Project: South Battery Park City Resiliency Project:
Wagner Park / Museum of Jewish Heritage
Site Work Construction Services Project
(the “Project”) Request for Proposals (“RFP”)

Date: July 12, 2022

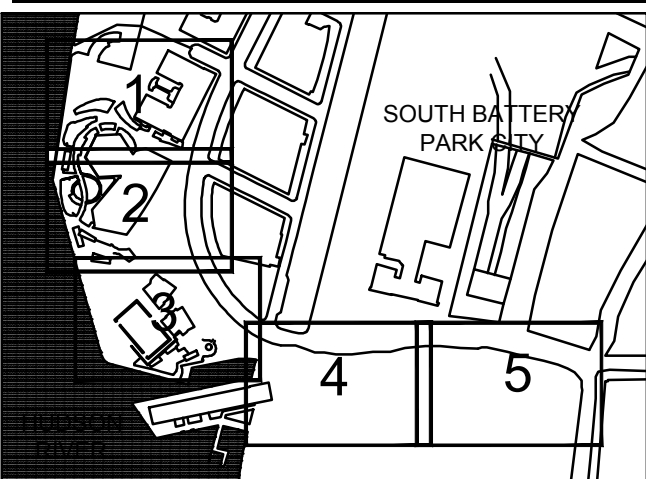
1/R	DATE	DESCRIPTION
1	06/22/22	ADDENDUM #1

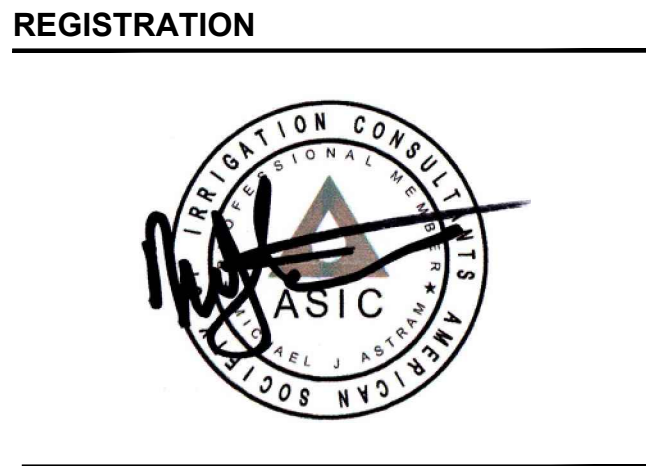
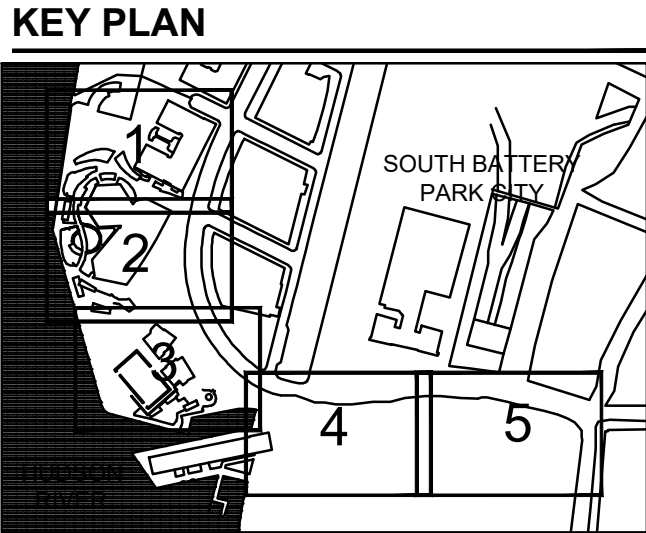
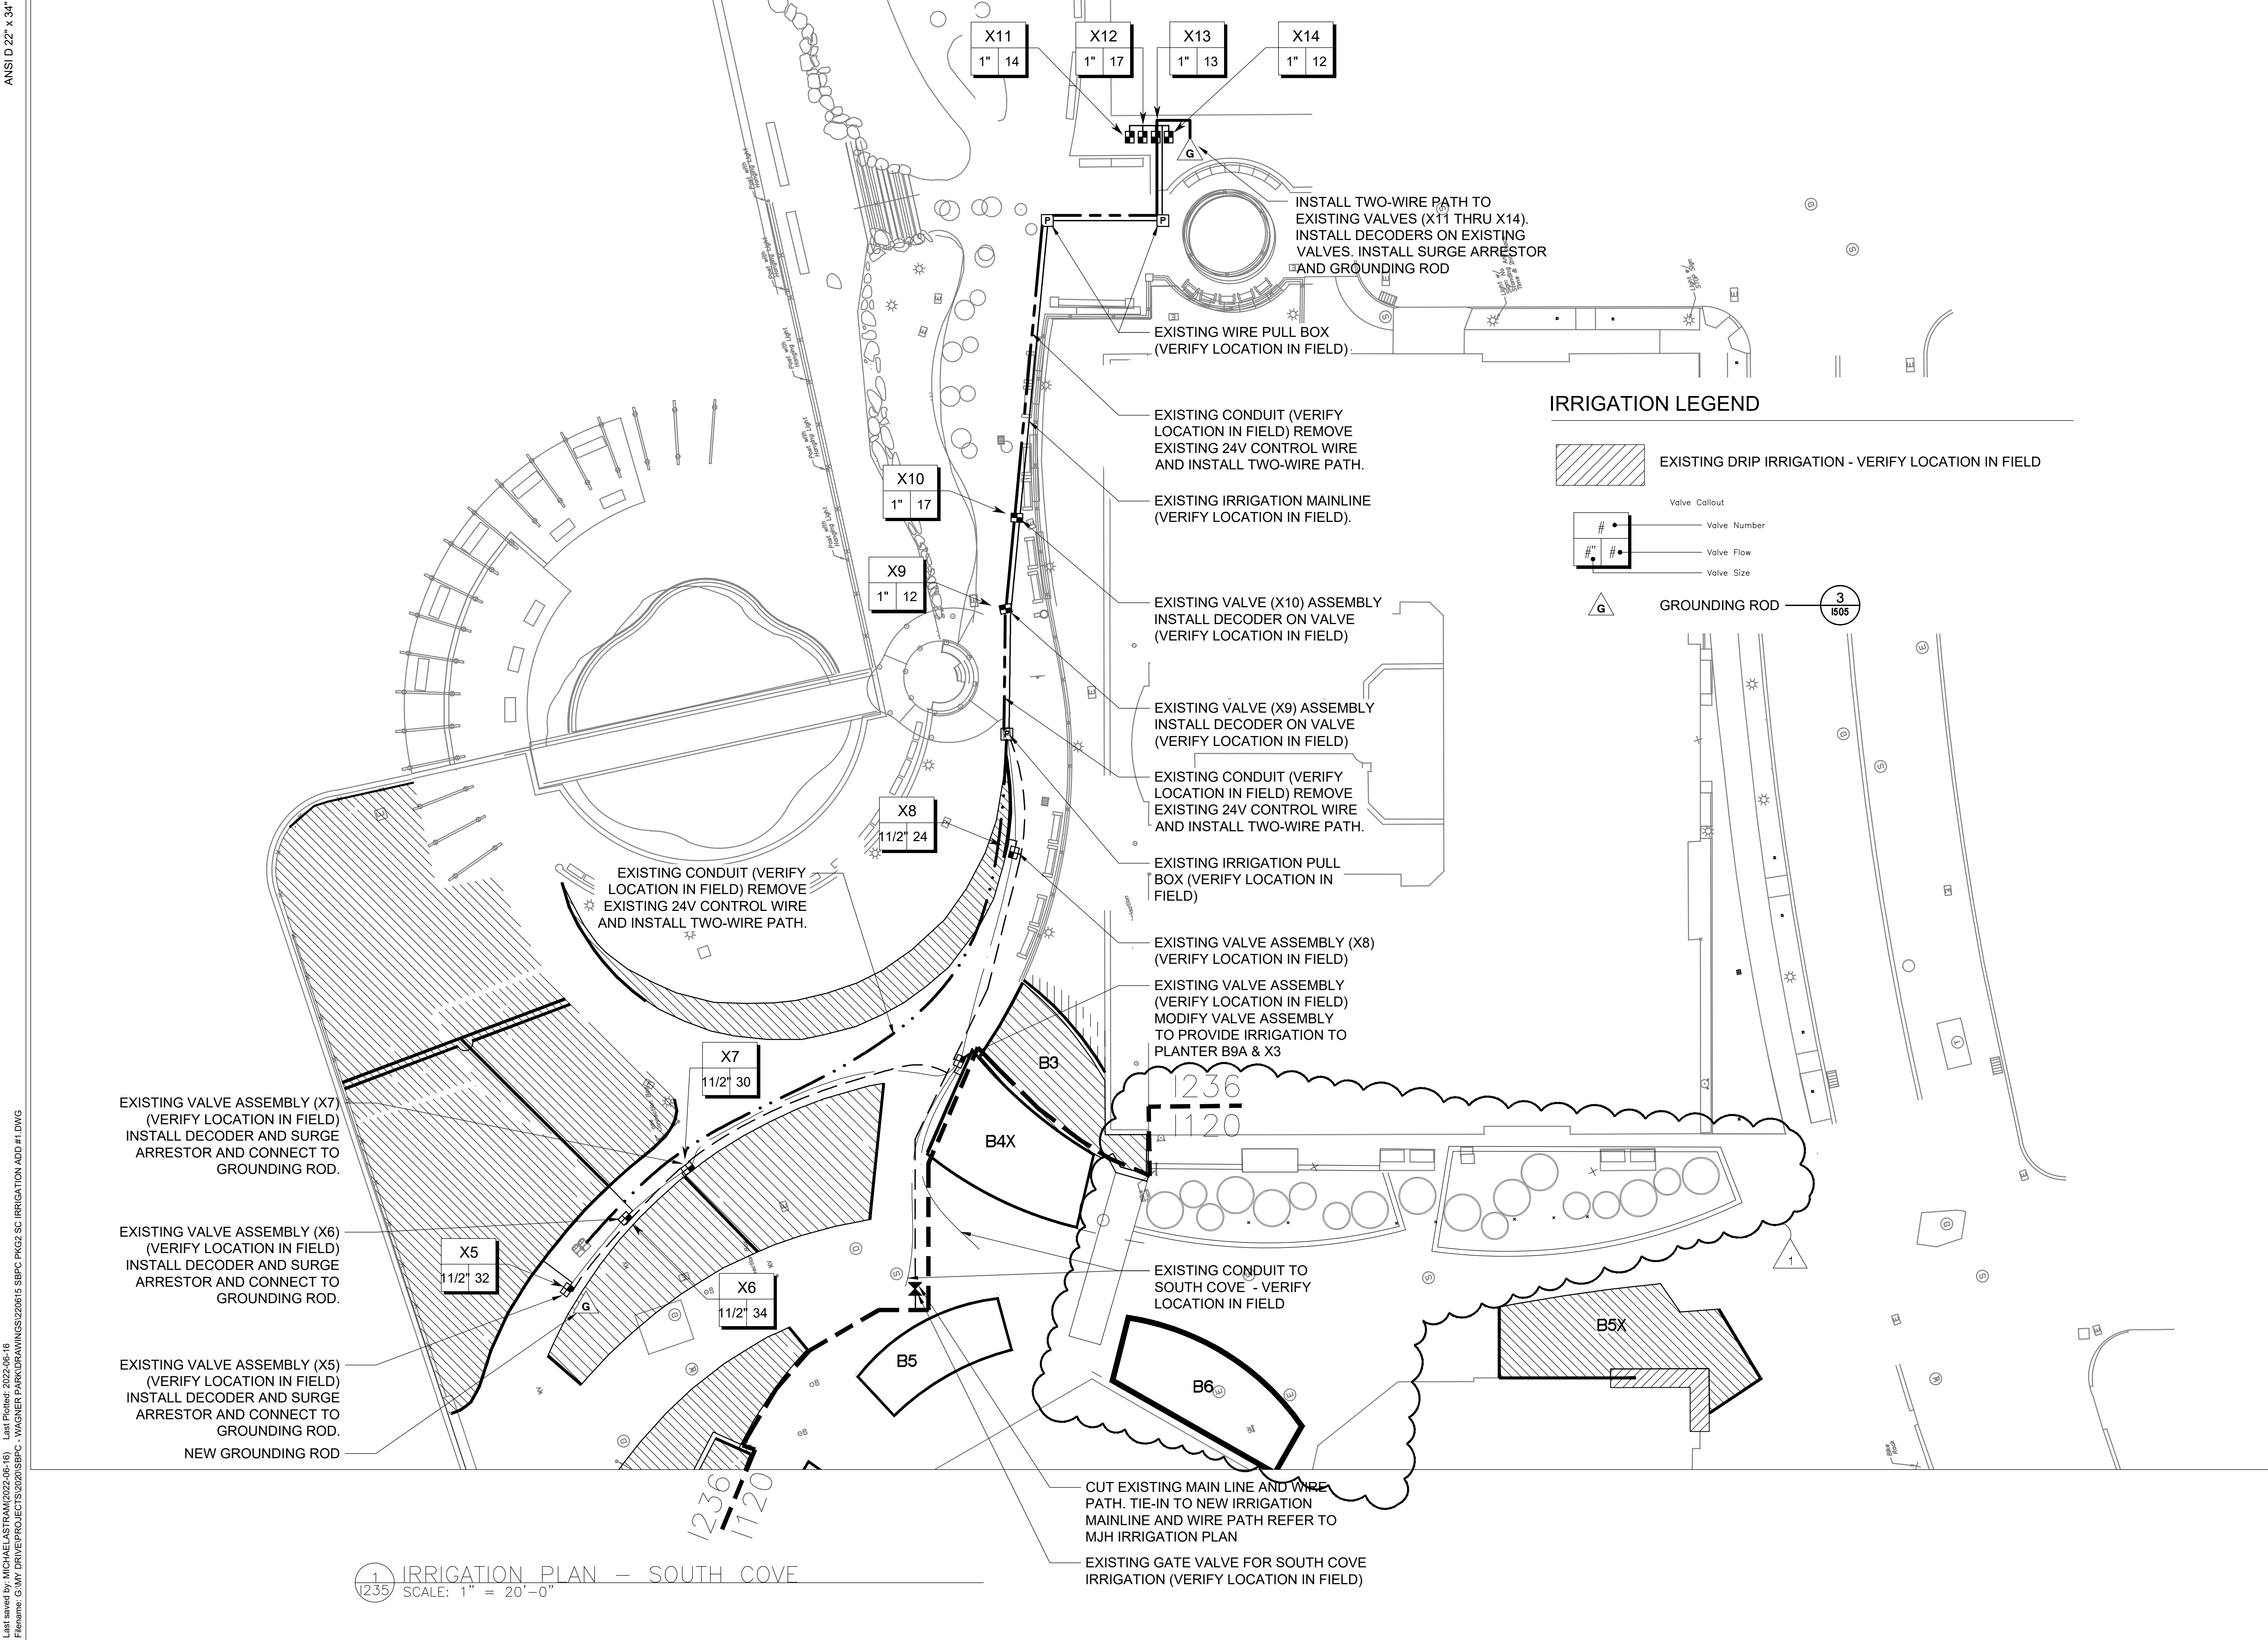
ISSUE/REVISION		
1	06/22/22	ADDENDUM #1
I/R	DATE	DESCRIPTION

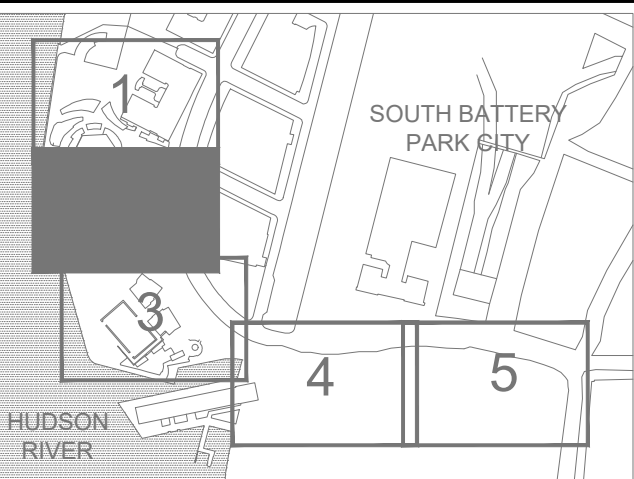
R	JULY 2022	ADDENDUM
I	JAN 2022	BID SET
I/R	DATE	DESCRIPTION

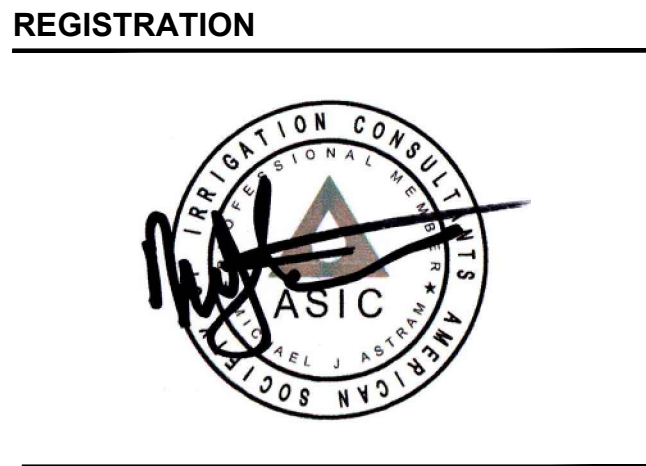
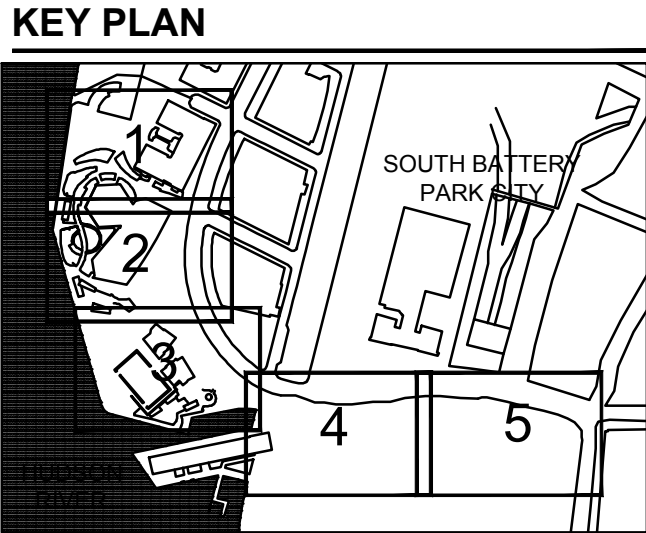
ISSUE/REVISION
1 06/22/22 ADDENDUM #1
I/R DATE DESCRIPTION
